# Site Suitability Analysis – Engineering Rebuttal Report

Block 1045, Lots 2-4 (1114 West Nut Swamp Road)

October 2, 2024

T&M Associates

Figure 1: Wastewater Management Plan Viewer (West Nut Swamp Road Site)

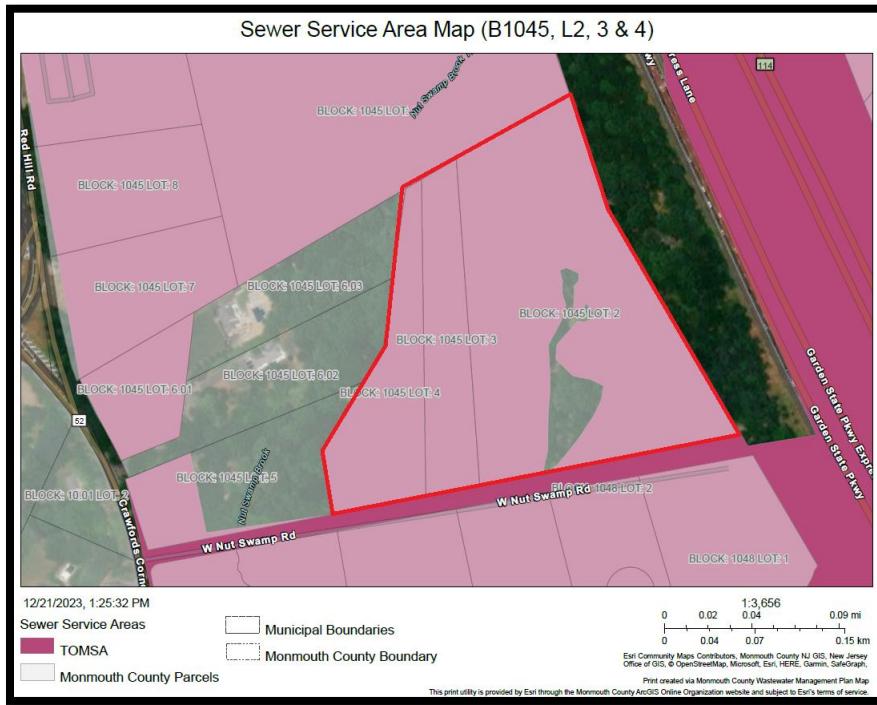
As can be seen from Figure 1 below, based on our review of the GIS data provided by the NJDEP and Monmouth County, the West Nut Swamp Road Site is located within the sanitary sewer service area operated by the Township of Middletown Sewerage Authority (TOMSA). A portion of Lot 2 is not located within the sewer service area. However, this area overlaps with wetlands and a state open water onsite, which have been verified by a Letter of Interpretation from NJDEP (referenced later in this report), and it does not appear that the Developer is proposing any Dwelling Units within same. The Developer has obtained a "Will Serve Letter" from TOMSA, indicating that TOMSA has capacity "at this time" to meet a 52,200 gpd sewage flow from the site.

*Figure 4: Sight Distance limitations at the West Nut Swamp Road and Crawfords Corner Road intersection. View from northbound approach on Crawfords Corner Road. (Photo taken by T&M on May 29, 2024)*

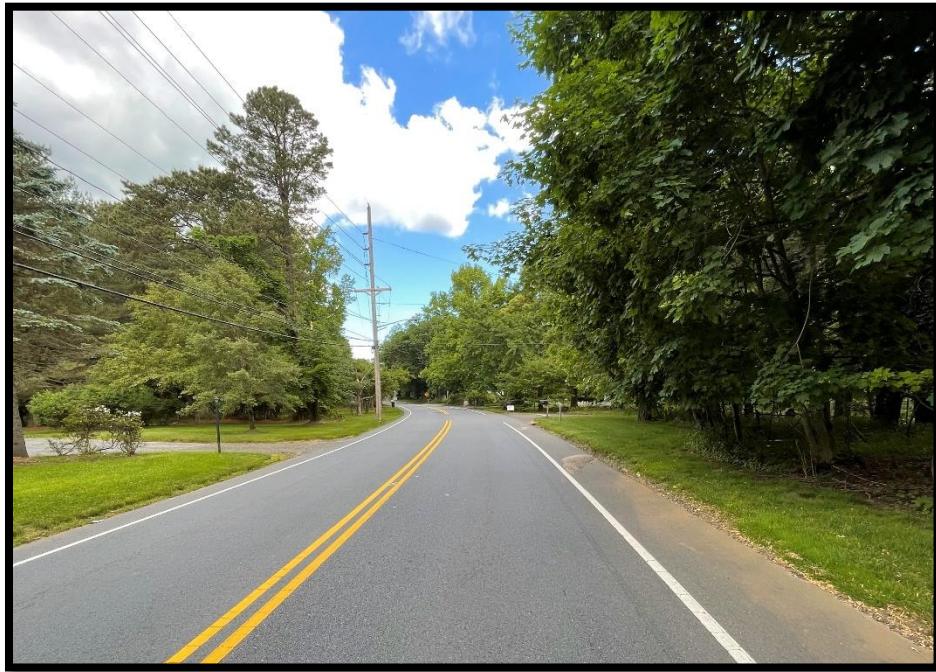
close to the public right-of-way. **Exhibit 3 shows that significant vegetation exists within the anticipated required County Sight Triangle Easement lines, as further illustrated by site photos taken by this office in Figures 3 through 5. The Developer may not be able to obtain permission from these property owners to remove any sight obstructions which fall upon private property.**
